The following items are conditions for permit issuance and strict compliance is mandatory.

FIGURE R602.10.6.4
METHOD CS-PF—CONTINUOUSLY SHEATHED PORTAL FRAME PANEL CONSTRUCTION

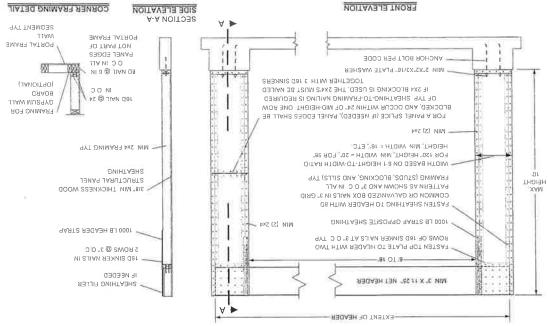
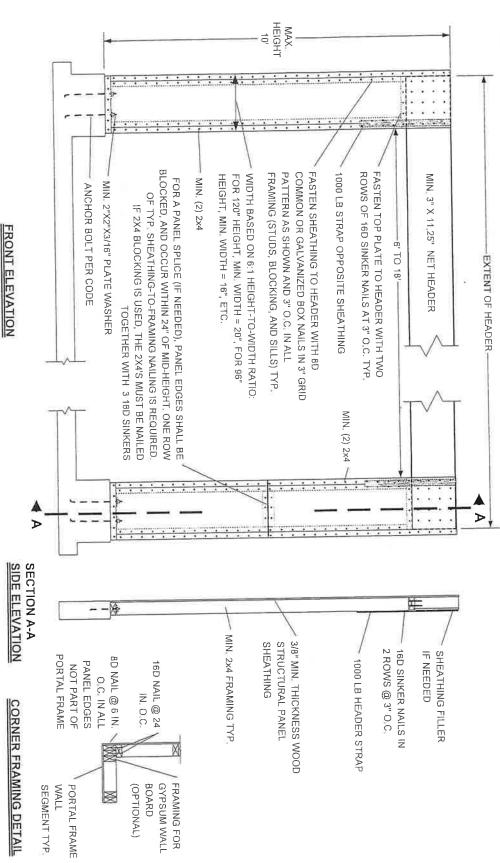
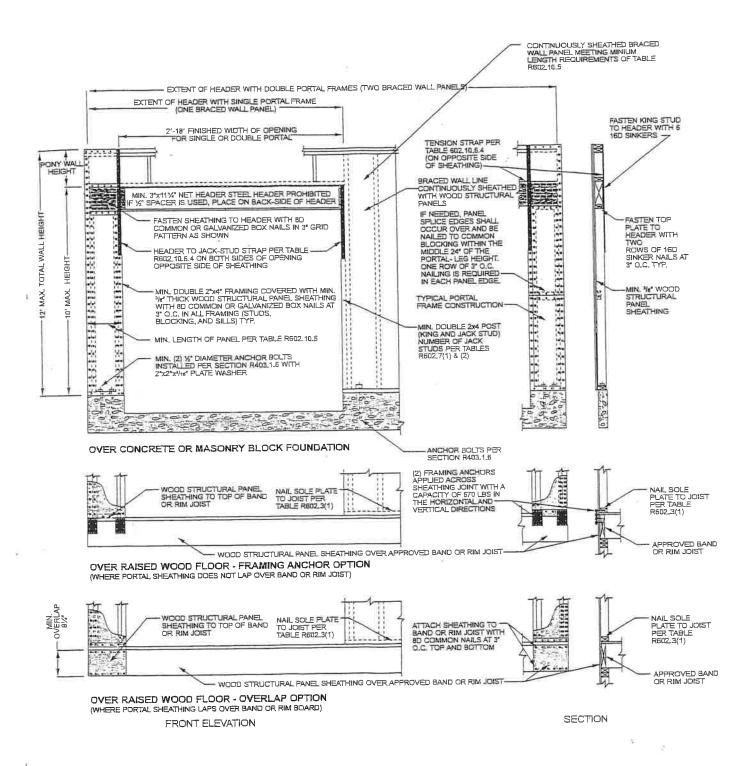
- 13. No final building inspection will be conducted prior to the installation of a water meter and a remote water meter read out.
- 14. Wall section on the front of the garage less than 2'-8" wide shall be braced wall panels.(see attached) MSBC1309/R602.10
